**Re: Written Ex Parte Presentation  
ARINC Inc. Application for Blanket Authority to Operate Aboard Aircraft Up To 1000  
Technically-Identical Transmit and Receive Mobile Earth Stations in the 11.7-12.2 and  
14.0-14.5 GHz Frequency Bands; File Nos. SES-AMD-20031223-01860 and SES-LIC-  
20030910-0126, Call Sign E030205**

## TECHNICAL ANALYSIS

**Figure A. Forward Uplink Off-Axis E.I.R.P. at Authorized and Nominal E.I.R.P. versus Individual AES Off-Axis E.I.R.P.**

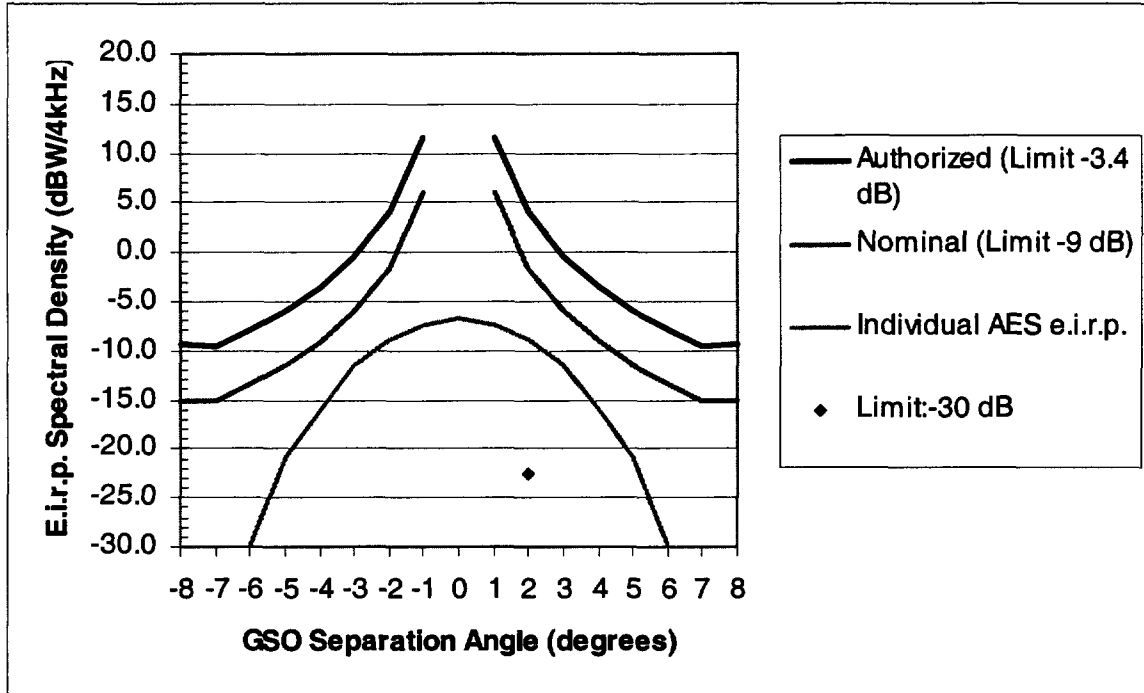
The ARINC Response states that "[t]he contribution of the fixed Ground Earth Station to off-axis e.i.r.p. is small in comparison to a single AES and does not change over time."<sup>34</sup> Boeing assumes that this statement refers to the forward uplink off-axis e.i.r.p. contribution of SKYLink feeder link earth stations, and strongly disagrees with this assertion.

Figure A shows that both the authorized and nominal off-axis e.i.r.p. of the forward (feeder link) uplink are 5 to 10 dB greater than the off-axis e.i.r.p. of a single AES at an e.i.r.p. density of -6.53 dBW/4kHz. Also shown in Figure A is a data point corresponding to 30 dB below the VSAT criteria at 2 degrees of orbital separation. The fact that off-axis e.i.r.p. of the forward uplink is constant only magnifies the problem since the contribution of a single AES is discounted by its relatively low duty cycle. While the forward uplink may contribute three to ten times more off-axis e.i.r.p. than a

single AES while it is transmitting, the forward uplink will contribute as much to the off-axis e.i.r.p. as 10 to 50 AESs that are logged in but only transmitting intermittently.

**Figure B. Aggregate AES Off-Axis E.I.R.P. and Total effect of AES and Uplink Off-Axis E.I.R.P.**

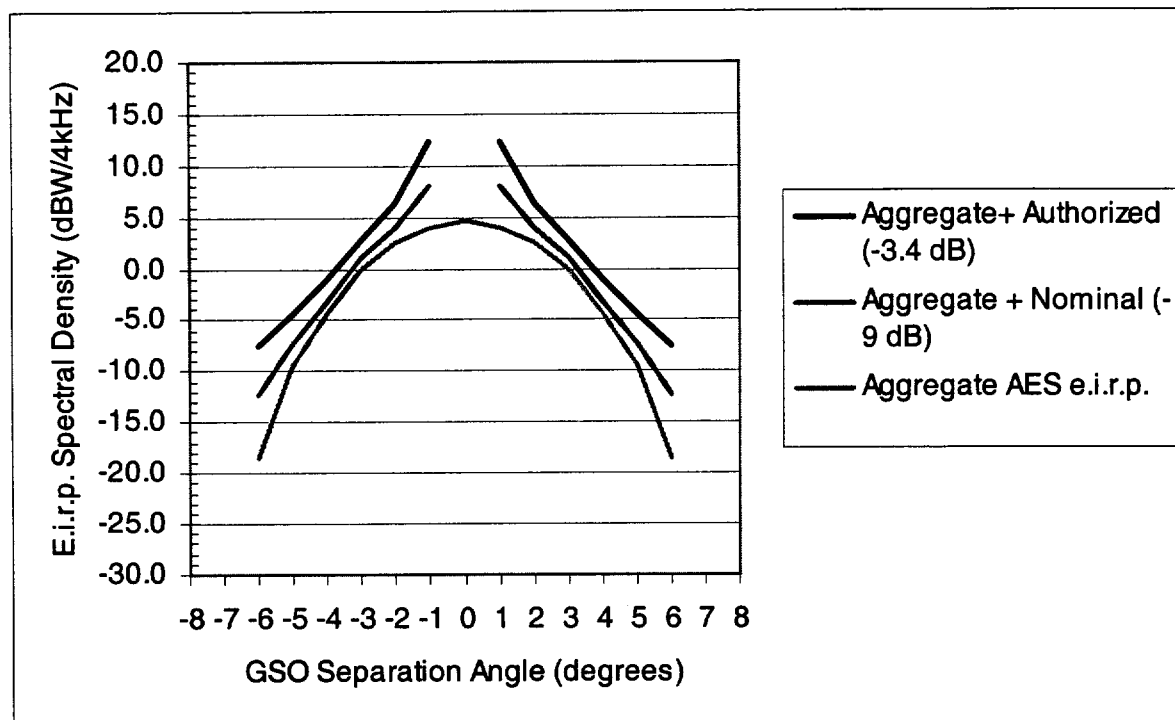
Figure B shows the aggregate AES off-axis e.i.r.p. as well as the total off-axis e.i.r.p. resulting from the sum of the uplink and AES signals. As shown, the total effect is several dB greater than just the aggregate of the AES signals. This would occur at a range of orbital locations.

As previously noted by Boeing, ARINC's forward uplink will increase the aggregate off-axis e.i.r.p. of the ARINC system by 45% if operated at the authorized input power level, 3.4 dB below the -14 dBW/4 kHz limit with a Rule 25.209 compliant antenna when the AES uplinks are at the off-axis e.i.r.p. limits.<sup>35</sup> ARINC now claims that it will actually operate this link at 9 dB below the -14 dBW/4 kHz limit.<sup>36</sup> However, Boeing has already noted that this would still significantly increase the aggregate off-axis e.i.r.p. by 12.5%.<sup>37</sup> In any event, the FCC must consider the forward uplink's maximum authorized uplink power level in assessing the overall interference potential of the SKYLink system. To the extent that ARINC requests the FCC to consider a reduced maximum authorized forward uplink power level (-23.01 dBW/4 kHz), it should formally modify its forward uplink earth station power to reflect this reduced level.
